| <b>Topic</b>           | Mulsanne - Camshaft Position - Diagnostic Trouble codes |
| <b>Transaction No.</b> | 2057991/1                                               |

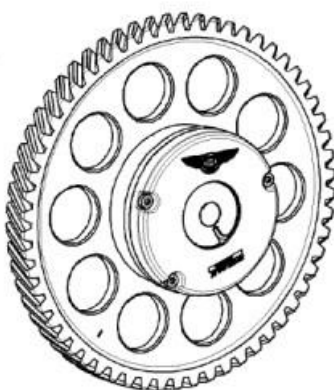
When the engine is cold increased friction within the camshaft adjuster unit may result in "*camshaft position*" DTC's being stored within the ECU. The concern can be resolved by replacing the camshaft timing gear with a "B" level part which utilises an internal return spring with higher rate. See *Parts information* below.

There are many possible DTC's related to this failure, the following is a typical example – *P001200 : A Camshaft position (Bank 1) timing over-retarded*.

With a confirmed customer complaint of uneven engine running and camshaft position DTC's stored within the ECU, replace the camshaft timing gear with a "B" level part.

| Part Number | Description                                      | Quantity |
|-------------|--------------------------------------------------|----------|
| 07V109227B  | Camshaft Gear (including camshaft adjuster unit) | One      |
